ONE 90 (PREVIOUSLY WATERS TECHNOLOGY PARK )  
PA 18-013 MODIFICATION SUBMITTAL :  
ISSUE DATE: 10-13-20

PA MODIFICATION - INTENT AND DESCRIPTION:  
To review and approve architectural building related design modifications made during plan check for code compliance and constructibility.

PA MODIFICATION COBALT- BLOCKS REVISIONS SUMMARY

PA MODIFICATION - INDIGO ROWS REVISIONS SUMMARY

SECOND LEVEL PLAN

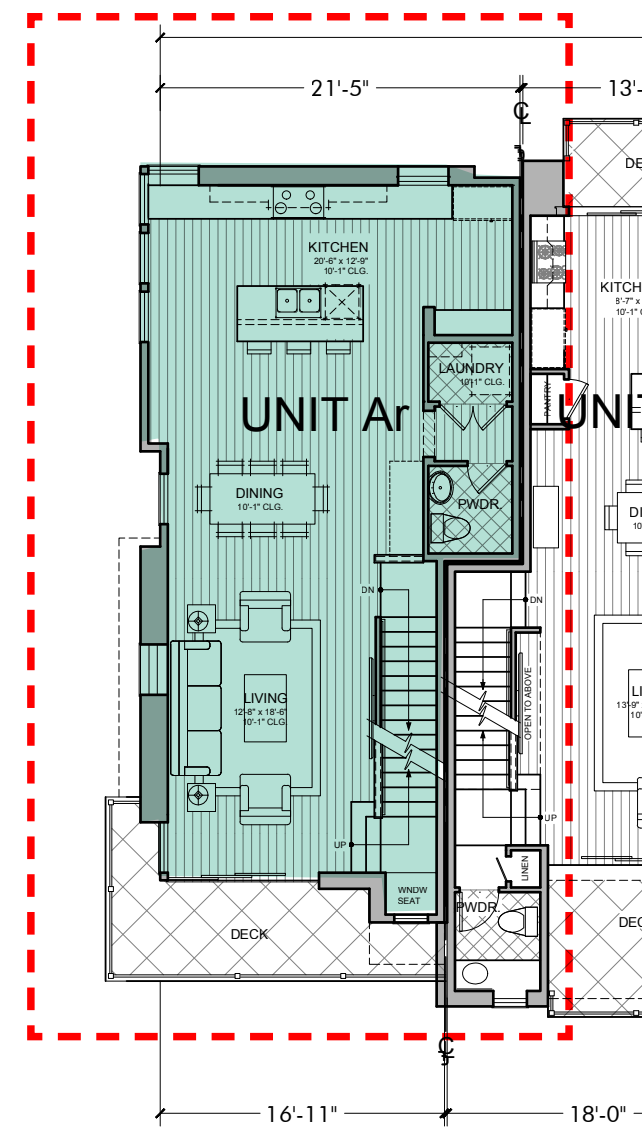
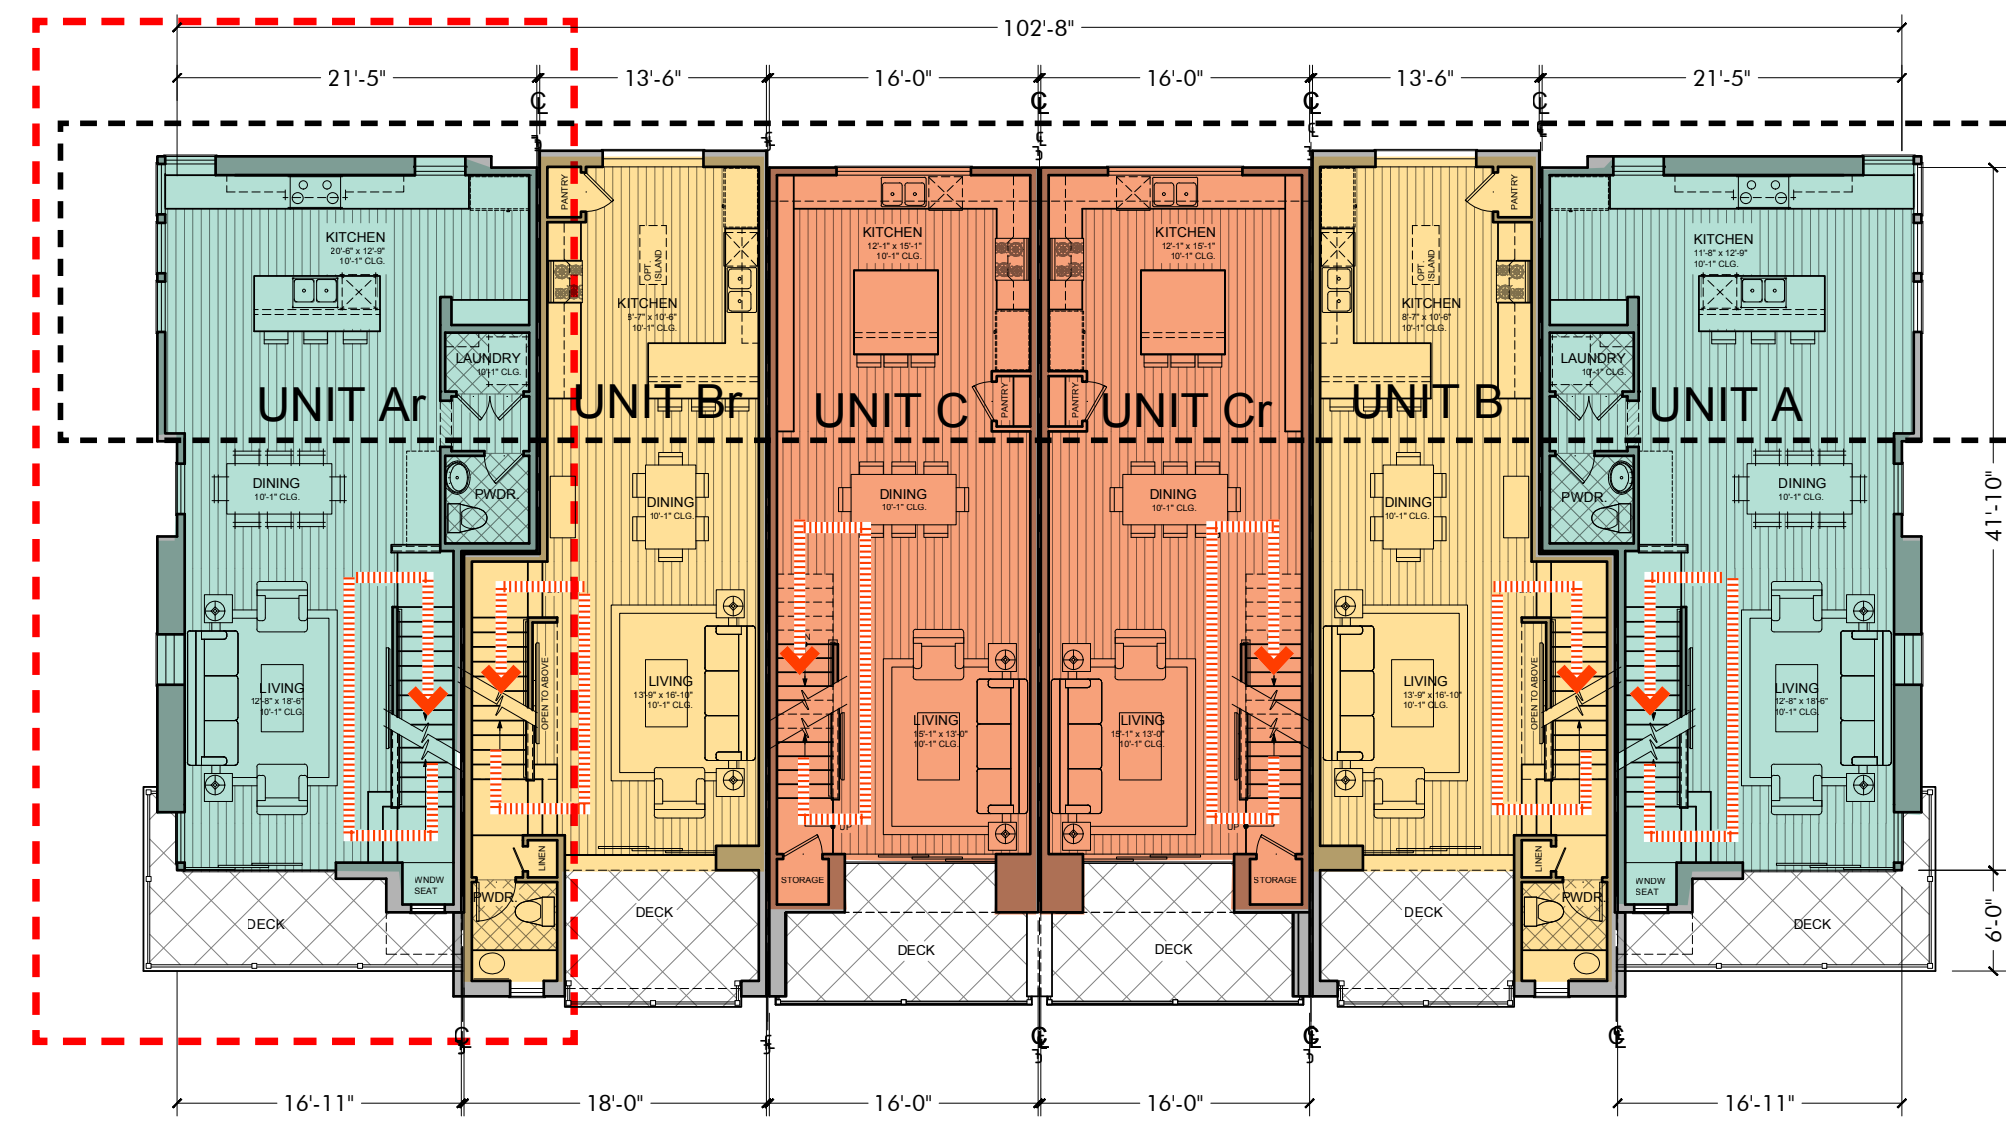
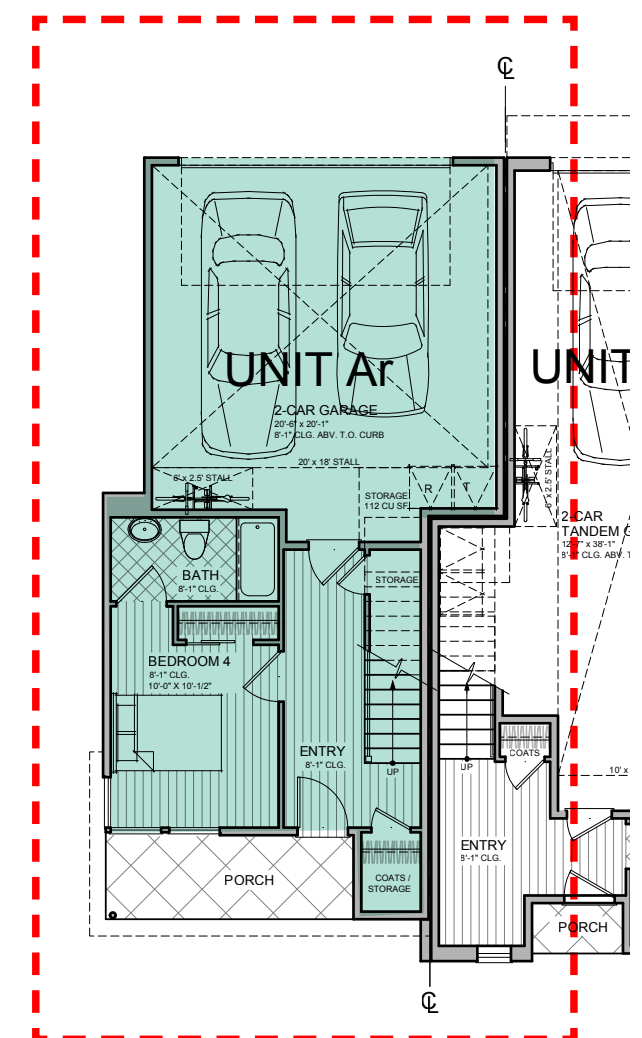
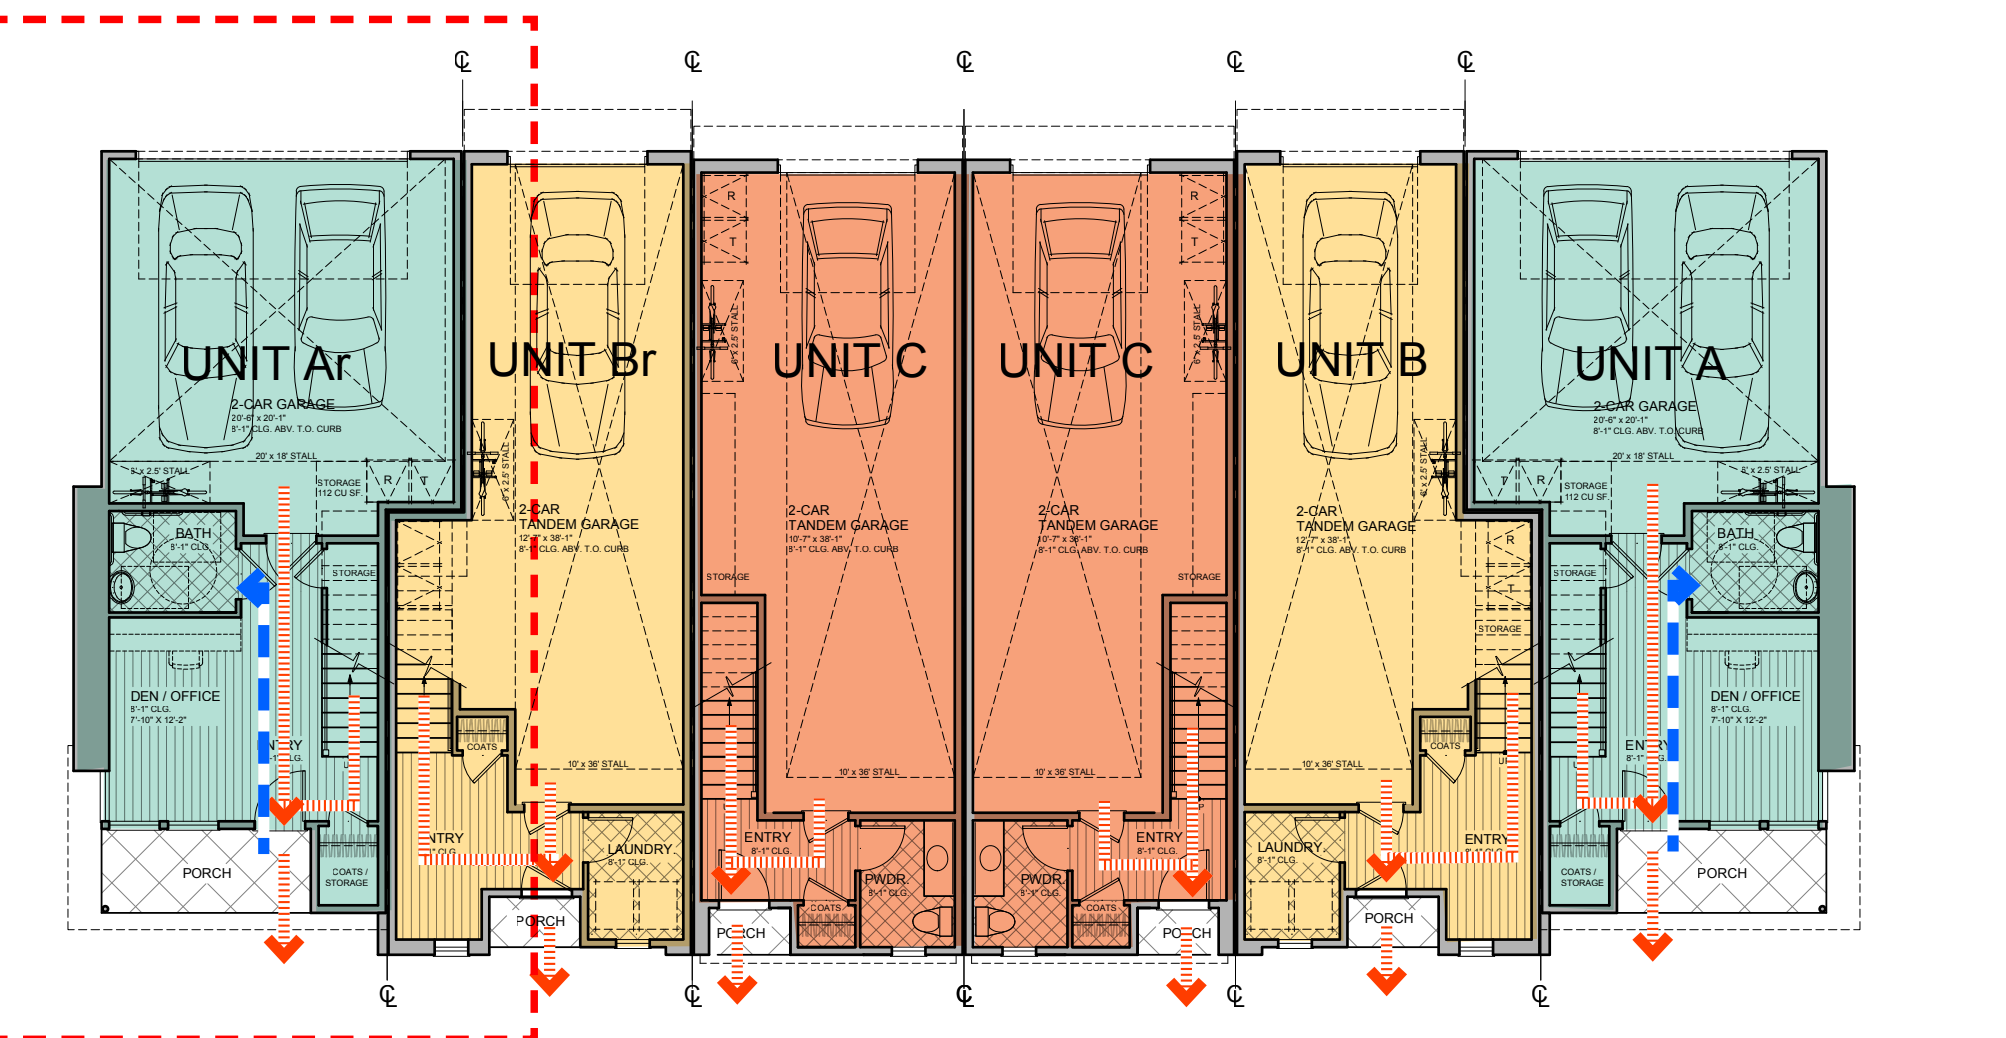
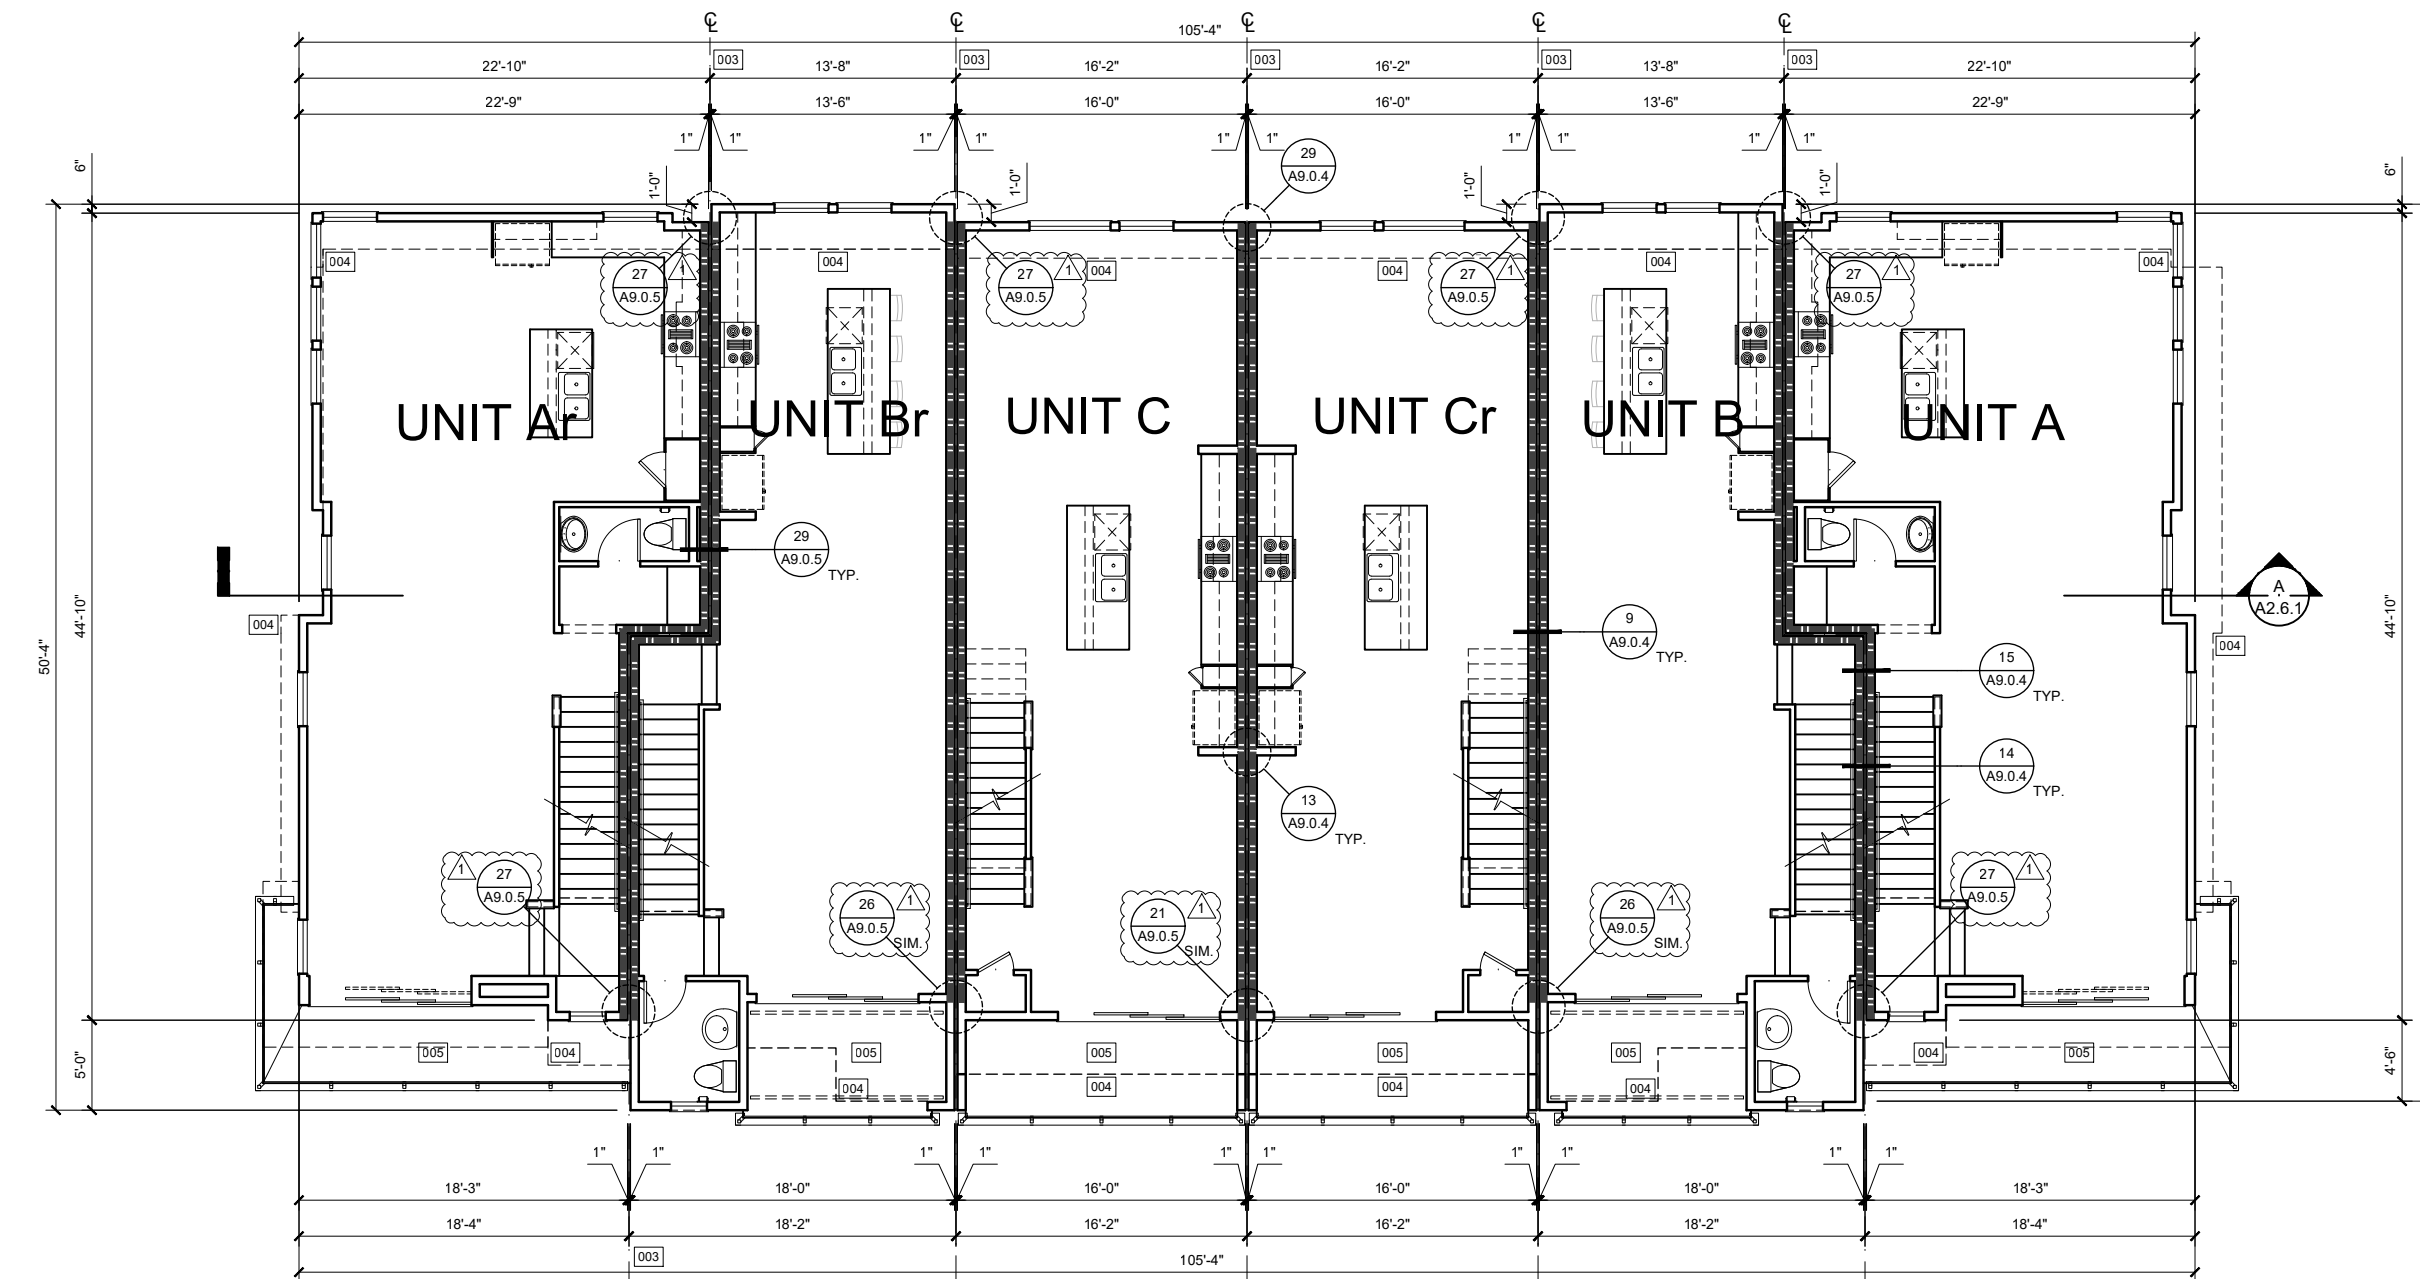
1. Added fire and electrical utility closets
2. Unit AX is revised to accommodate Bedroom 4 and Bath 3 in 5 plex and all 6 plex buildings per PA 18-013 vignette for TH 10

Please note that PA 18-013 plans did not include dimension and the second floor dimensions were measured to interior of the walls and did not include any dimensions to exterior pop out walls.
